GRUNDIG

**SERVICE
INFORMATION
BULLETINS
1999**

Figure 1

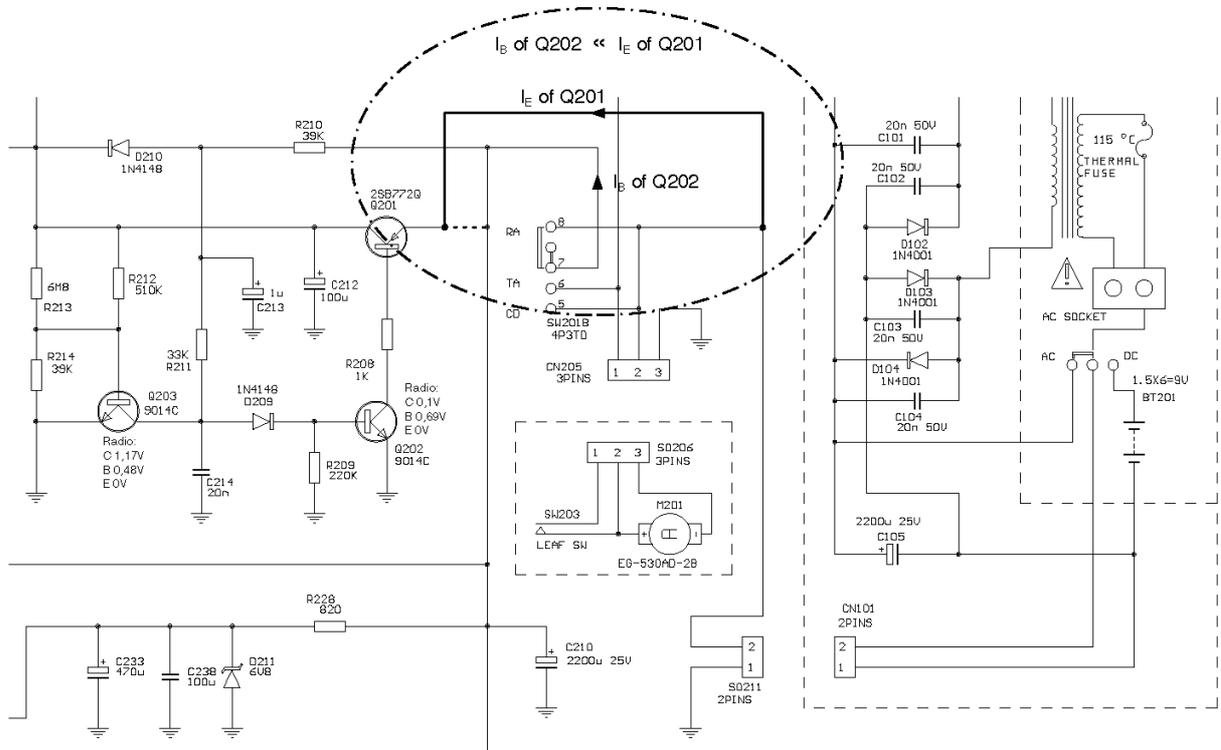
The contacts (7-5) of switch SW 201B become charred so that they do no longer contact.

The switching contact provides the voltage for both the CD servo system and the audio power amplifier.

Connect the emitter of Q 201 directly to the voltage supply. The switch is only used for controlling the base current which is much lower than the emitter current. Fig. 1 (see page 2)

Figure 2

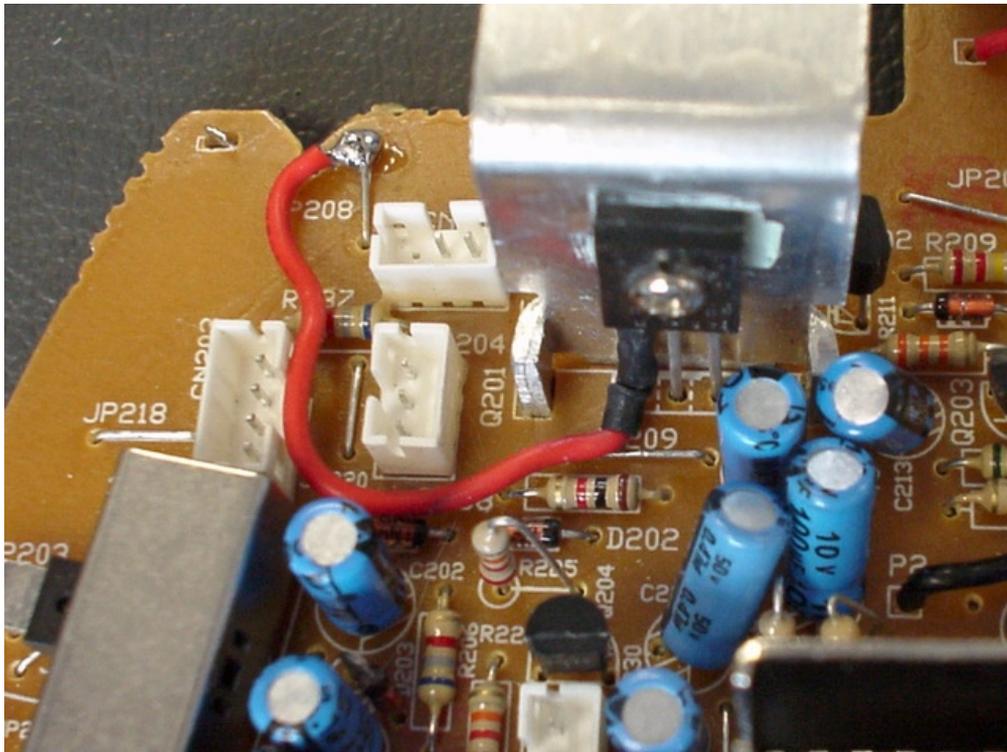
For repair: Fig. 2 (see page 2)

- a) Replace the slide switch.
- b) Disconnect the emitter of Q 201 from the circuit board using a wire cutter (or soldering iron).
- c) Solder a stranded wire (length=50 mm) to the emitter of Q 201 and insulate the solder joint with a piece of tube.
- d) Solder the other end to the jumper JP 208.
- e) Check the radio receiver and re-assemble it.

GDV 100 D

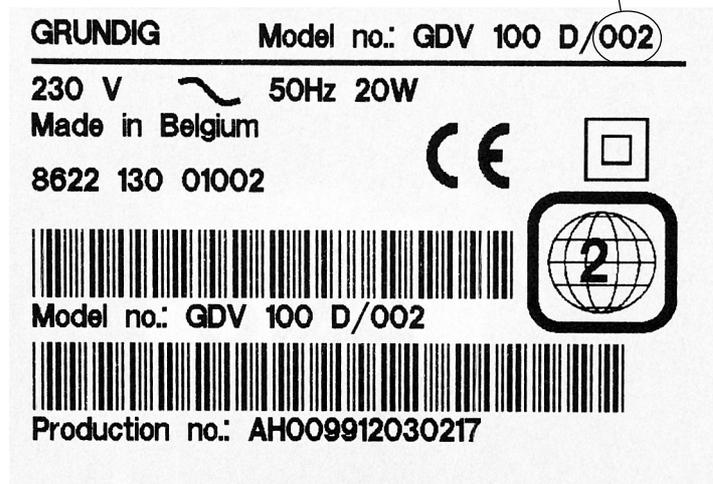
Changed version of DVD Player GDV 100 D

Both versions of the GDV 100 D Player are identifiable outside only by the label (on the rear side).

The two versions of the GDV 100 D Player work internally with different operating voltages. This is especially critical because the modules of both versions fit mechanically into each other.

When replacing modules take care to use only the appropriate modules for the version.

New type of picture tube for 72cm colour television receivers with chassis CUC 6365 / 6331

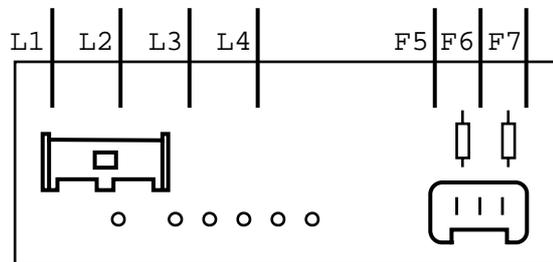
The picture tubes A 68 ESF 002X11, A 68 ESF 002X011 (without coating) and A 68 ESF 202X11, A 68 ESF 202X011 (with coating) fitted into television receivers with above mentioned chassis are no longer available. These picture tubes are not fully compatible with the replacement tubes A 68 ESF 002X111 / A 68 ESF 202X111.

- changed yoke connections:

The figure below shows the connections of the deflection unit for the new picture tubes A 68 ESF 002X111 and A 68 ESF 202X111.

- L1 - red yoke connecting lead (horizontal)
- L2 - black yoke connecting lead (horizontal)
- F5 - green yoke connecting lead (vertical)
- F7 - white yoke connecting lead (vertical)

<p>A 68 ESF 002X11 A 68 ESF 202X11</p>	<p>A 68 ESF 002X111 A 68 ESF 202X111 An existing seagull correction board is to be removed. The yoke connecting leads are soldered directly to the deflection unit (see figure).</p>
<p>A 68 ESF 002X011 A 68 ESF 202X011</p>	<p>A 68 002X111 A 68 202X111 No change. Connect the picture tube as shown in the figure.</p>

1. Colour television receivers ST 84-796/9 TOP/LOG, M 84-210/8 IDTV/LOG, M 84-210/8 A IDTV/LOG

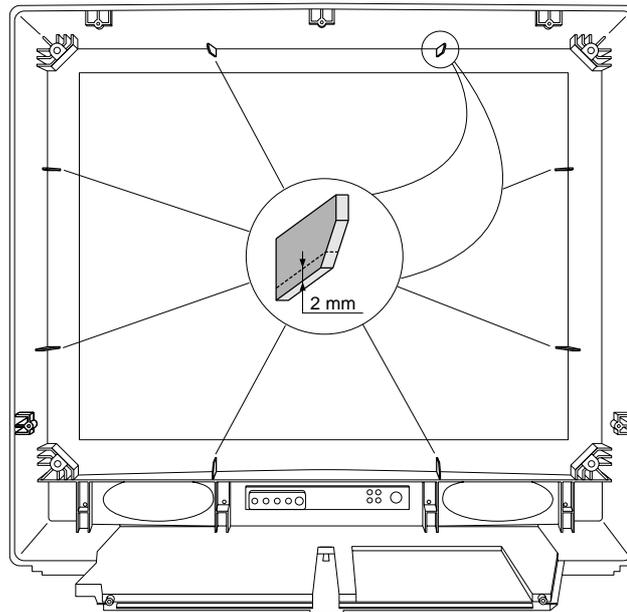
The picture tubes A80 EFF 002X11 (ST 84-796/9 TOP/LOG) and A80 EFF 002X42 (M 84-210/8 IDTV/LOG, M 84-210/8 A IDTV/LOG) fitted to a.m. models are no longer available. These tubes are mechanically not fully compatible with the replacement tubes A80 EFF 272X11 / A80 EFF 272X43.

Due to the slightly larger overall dimension, the picture tube touches the fixing ribs within the cabinet. Consequently, when changing the tube, these ribs must be cut by about 2mm (see figure).
